## UNITED STATES ENVIRONMENTAL PROTECTION AGENCY

March 15, 2004

Conditional Approval of General Electric's Work Plan Phase 3 Floodplain Properties, Group 3A, 3B, 3C, and 3D, 8 January 2004, General Electric/Housatonic River Project Site,

## Group 3C. Refer to Figure 4 (Attached).

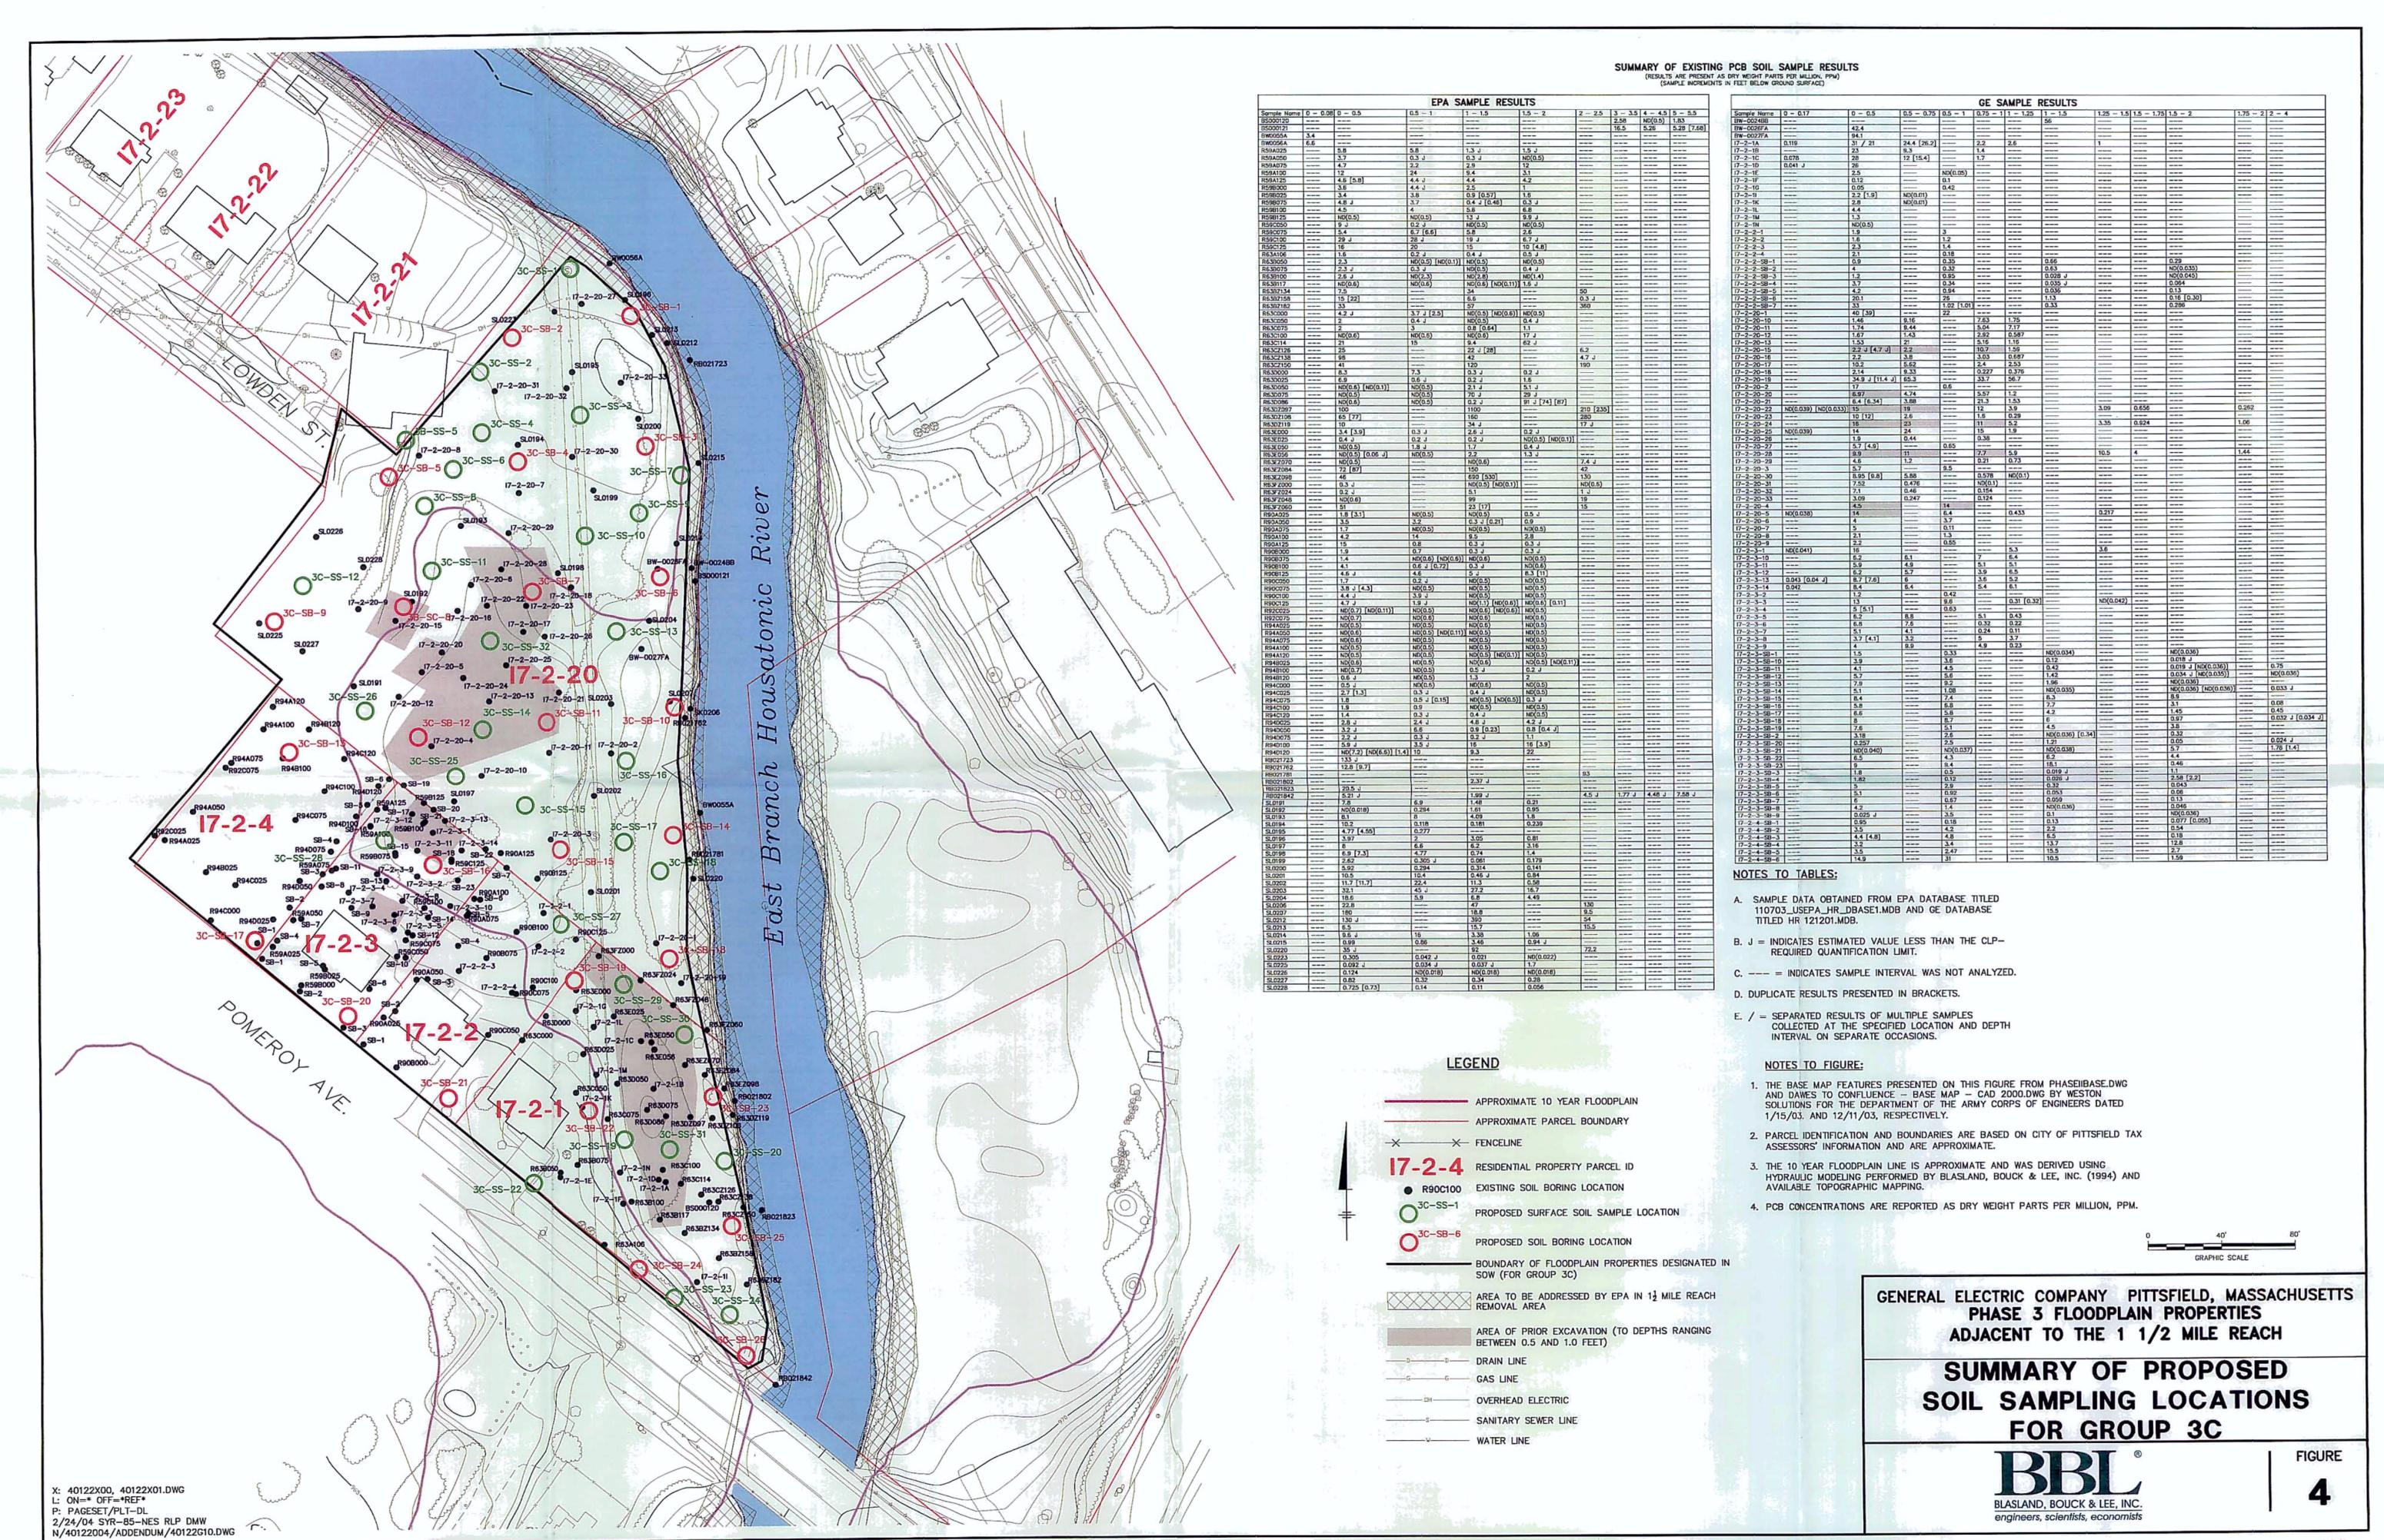
#### Lot 17-2-1

- 1. Move location 3C-SS-24 approximately 15ft northeast to a location between existing sampling locations 3C-SB-26 and I7-2-1I.
- 2. Eliminate location 3C-SS-21.
- 3. Replace surface sample 3C-SS-22 with boring 3C-SB-24.
- 4. Replace boring 3C-SB-24 with surface sample 3C-SS-22.
- 5. To further evaluate previously remediated areas, add the following surface soil sampling locations:
  - 3C-SS-29, between existing sampling locations R63E000 and R63FZ024;
  - 3C-SS-30, between existing sampling locations R63FZ048 and R63EZ070; and,
  - 3C-SS-31, between existing sampling locations R63DZ097 and R63C100.

## Lot 17-2-2

1. Add surface soil sample location, 3C-SS-27, between existing sampling locations 17-2-2-1 and R90C125.

#### Lot 17-2-3

1. Add a surface sample location, 3C-SS-28, approximately centered between R59A100 and R59B075.

#### Lot 17-2-20

- 1. Move proposed surface soil sampling location 3C-SS-16 northwest to a location northeast of existing sampling location SL0202, so that it lies in a topographically lower area to better define the extent of contamination of surface soils within the 10-year floodplain.
- 2. Add a surface soil sample location, 3C-SS-25, between existing sampling locations SB-19, SLO197, and I7-2-20-10.
- 3. Add a surface soil sample location, 3C-SS-26, between existing sampling locations R94B120 and I7-2-20-12.
- 4. Add a surface soil sample location, 3C-SS-32, between existing sampling locations 17-2-20-20 and 17-2-20-17.

SUMMARY OF PROPOSED SOIL SAMPLING LOCATIONS FOR GROUP 3D

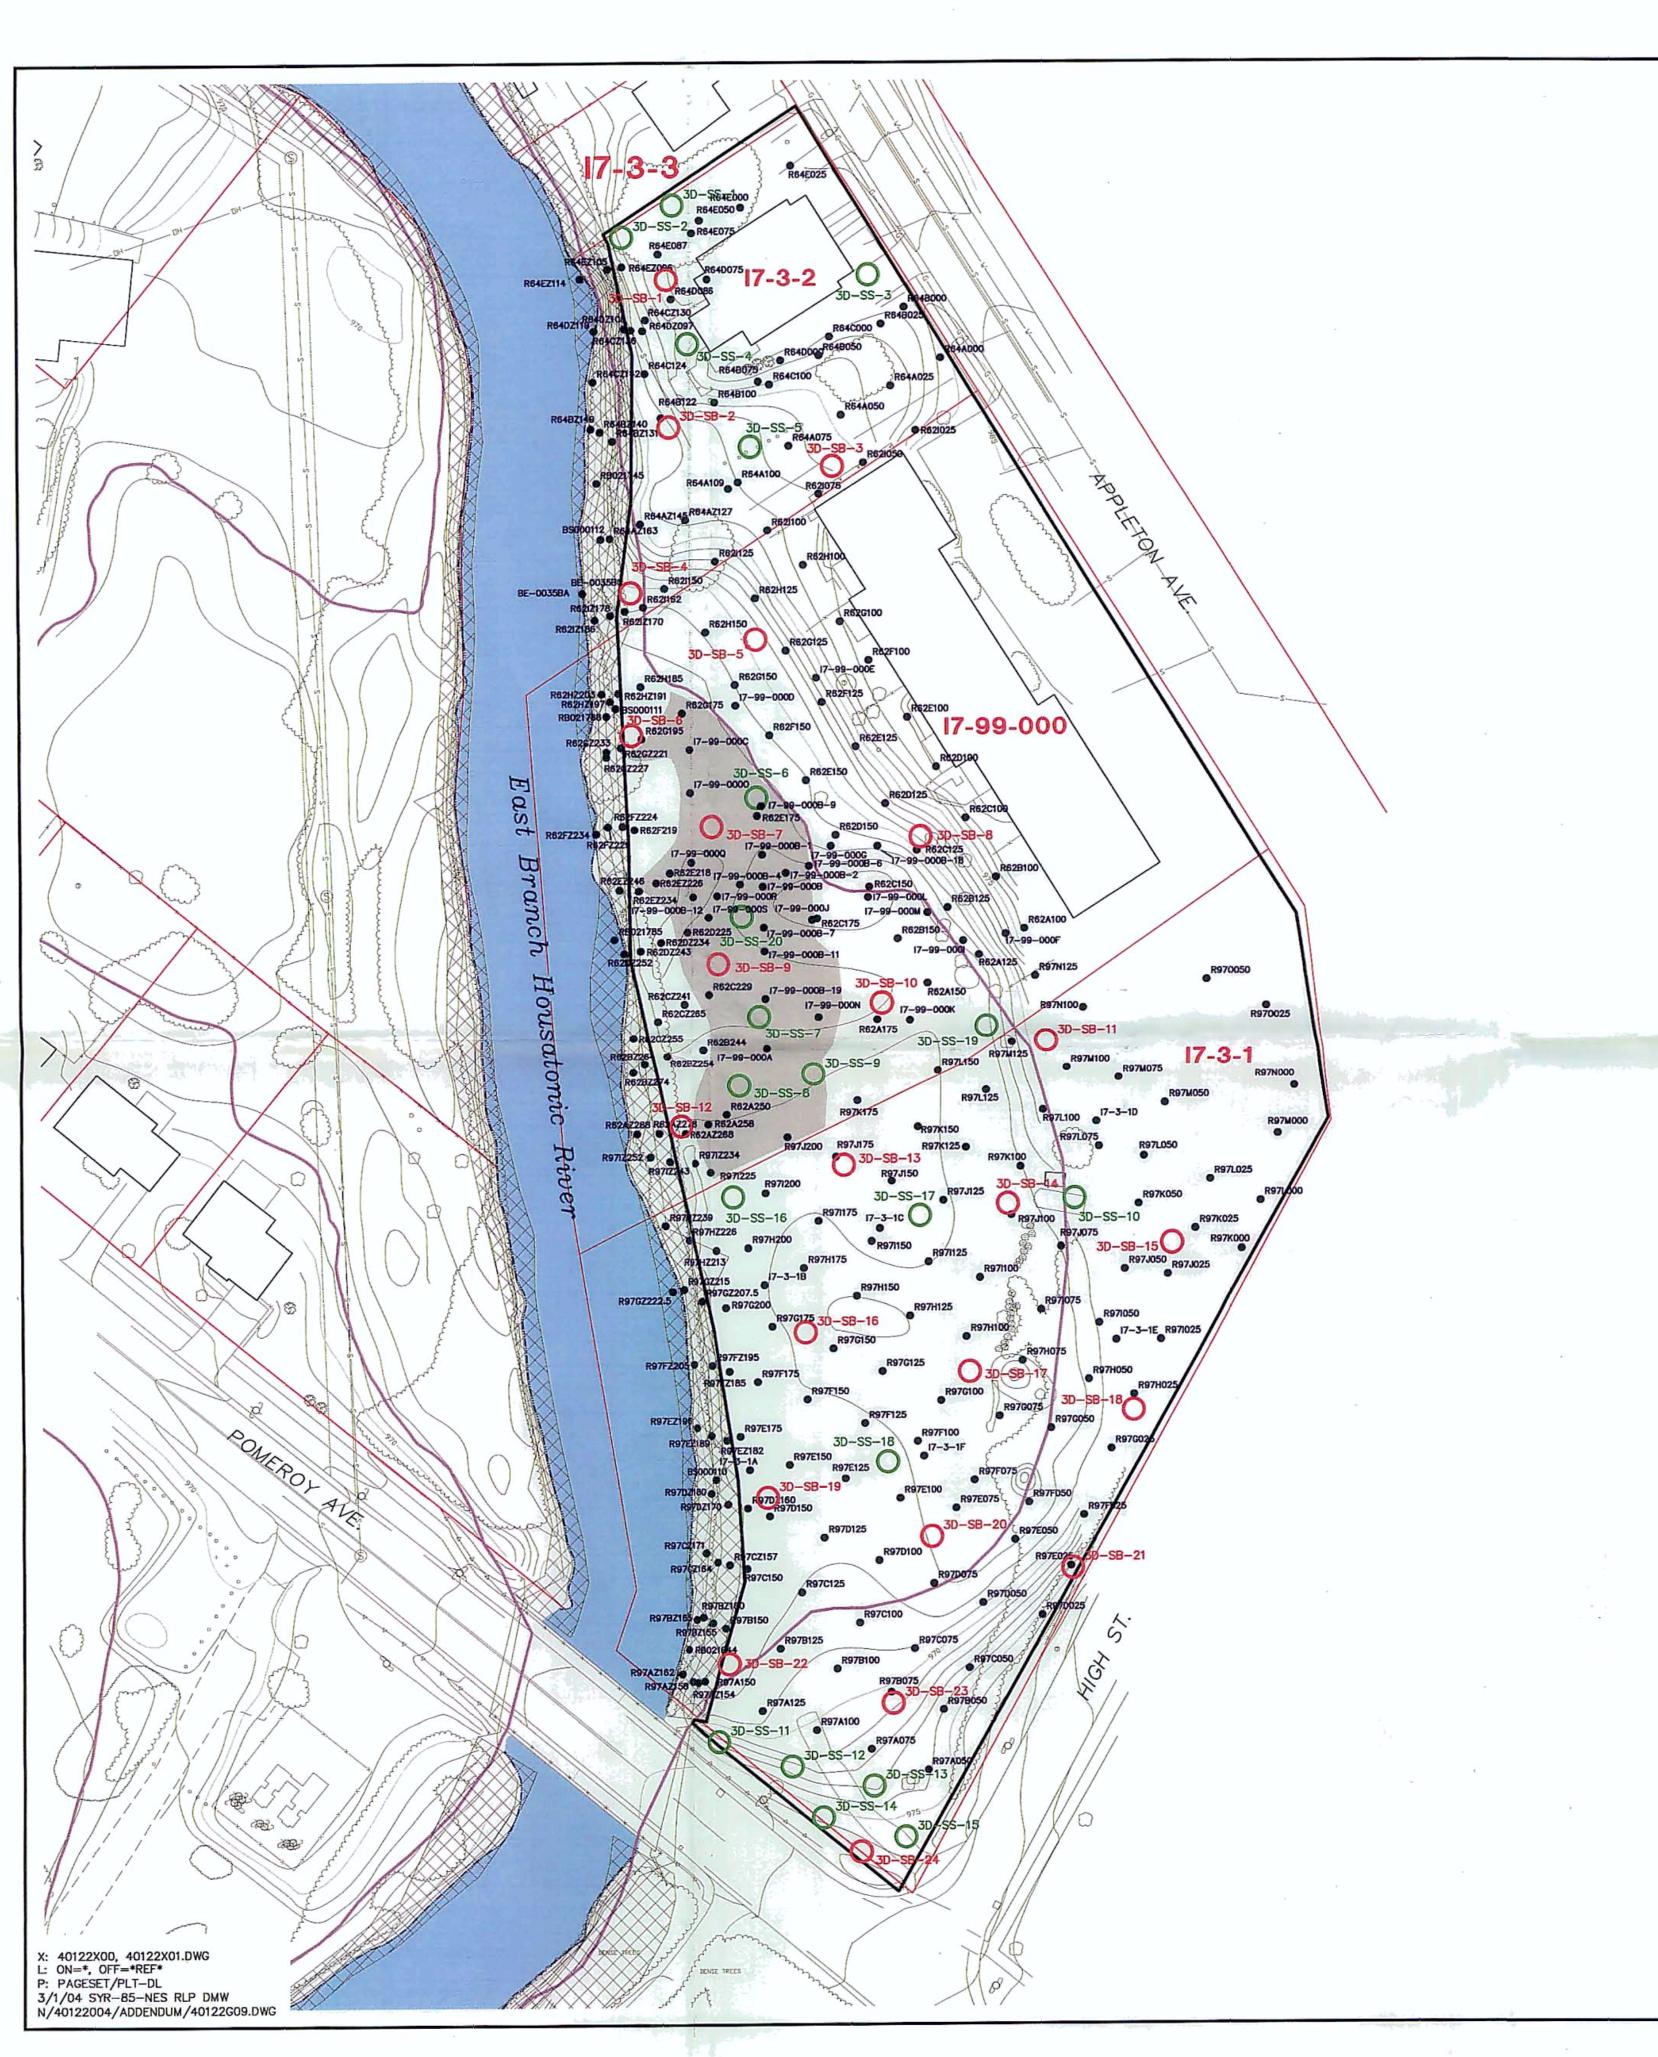
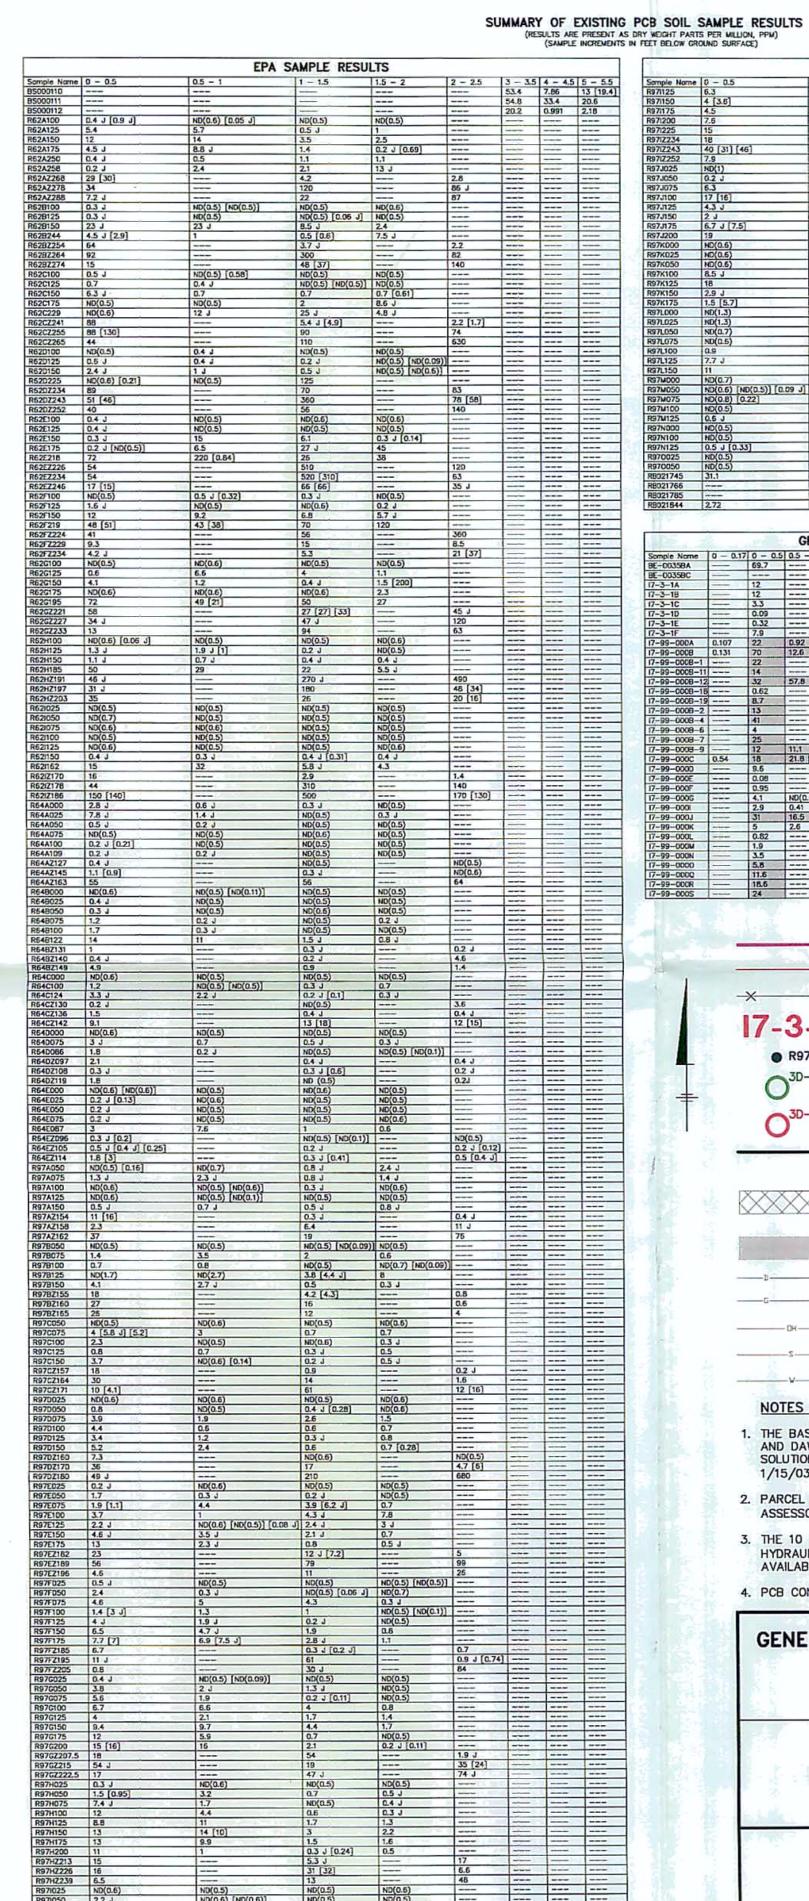
Group 3D. Refer to Figure 5 (Attached).

#### Lot 17-3-1

- 1. Add a surface sample location, 3D-SS-16, between existing sampling locations R97HZ226 and R97I200.
- 2. Add a surface sample location, 3D-SS-17, between existing sampling locations R97I150 and R97J125.
- 3. Add a surface sample location, 3D-SS-18, between existing sampling locations R97F125 and R97E100.

#### Lot 17-3-2

1. Move proposed soil boring location 3D-SB-1 approximately 15ft southwest to the vicinity of existing sampling location R64D086.

#### Lot 17-99-000

- 1. Move boring 3D-SB-5 approximately 15 to 20ft west to a lower elevation.
- 2. Add a surface soil sampling location, 3D-SS-19, between existing sampling locations R97L150 and R97N125.
- 3. Add a surface sample location, 3D-SS-20, between I7-99-000B-7 and I7-99-000R.
- 4. Replace surface sample 3D-SS-6 with boring at 3D-SB-7.
- 5. Replace boring 3D-SB-7 with surface sample 3D-SS-6.
